## RE-EVALUATION FORM

A. Re-evaluation Type: Design Change

**Project Name:** SR 5 (US 17/MAIN ST) FROM NEW BERLIN ROAD TO PECAN PARK ROAD

**Project Limits:** SR 5/US 17/Main Street from New Berlin Road to Pecan Park Road

**Figure 2: PD&E Concept Typical Section**

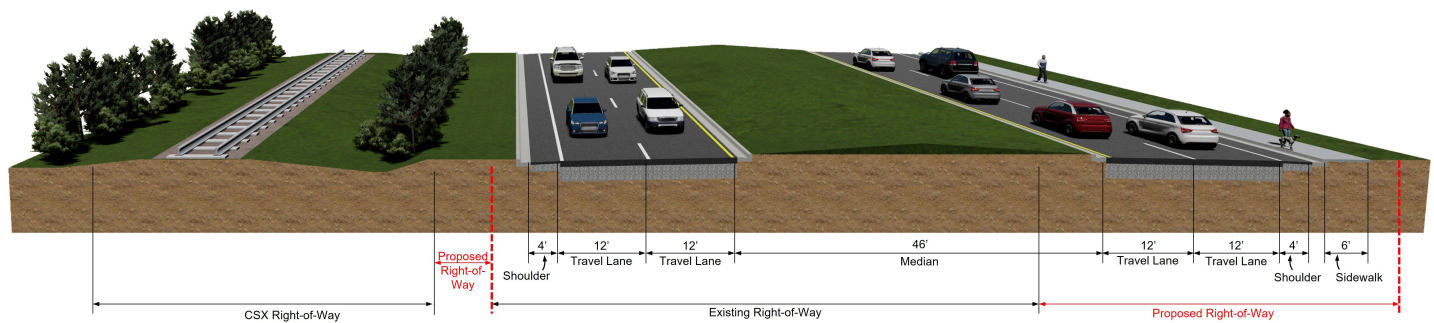
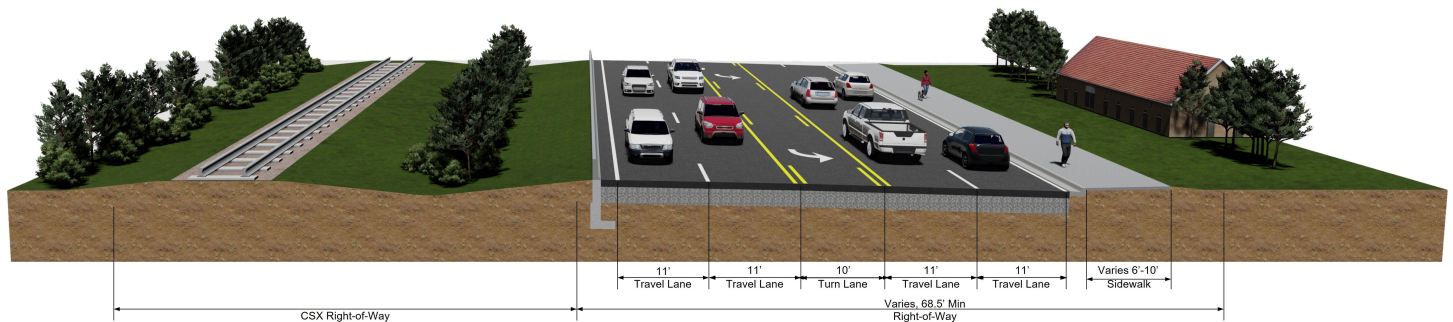
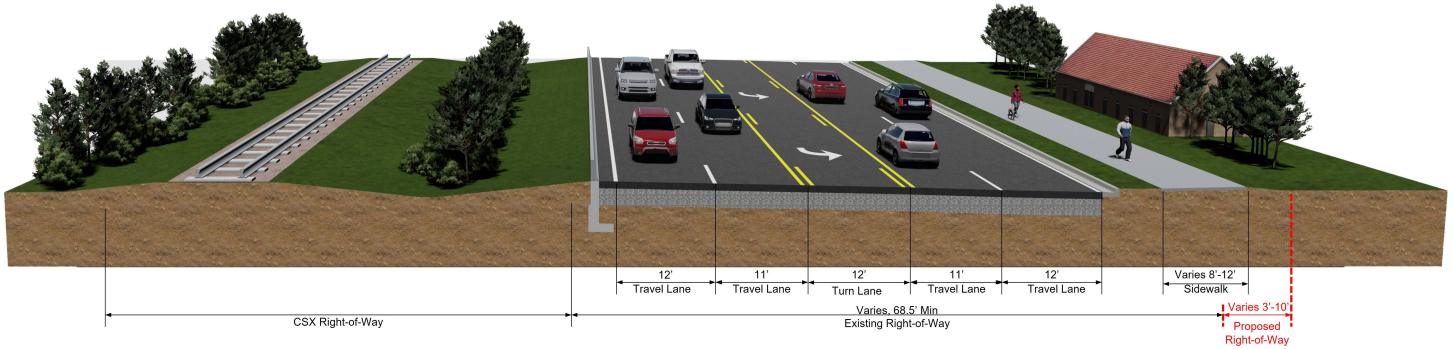
The PD&E Concept typical section consisted of four 12-foot travel lanes, a 46-foot median and four-foot bike lanes as well as a six-foot sidewalk in the northbound direction. No sidewalk was proposed on the west side due to proximity to the CSX railroad (see Figure 2). The right-of-way (ROW) of the proposed PD&E typical section varies throughout the project with a minimum of 130 feet.

The Design Concept typical section consists of two 11-12 foot travel lanes, a center 10-12 foot turn lane, and a 6-12 foot sidewalk on the east side. No additional ROW is needed from New Berlin Road to Airport Center Drive. Additional ROW from Airport Center Drive to Max Leggett Parkway/Duval Station Road varies from 3 to 10 feet in width.

Figure 3 shows the Design Typical Section on US 17 from New Berlin Road to Airport Center Drive. Figure 4 shows the Design Typical Section on US 17 from Airport Center Drive to Max Leggett Parkway.

Therefore, the typical section for the proposed widening was changed during the Design phase. The Design Concept replaced the 46-foot median with a single 10-12 foot turn lane.
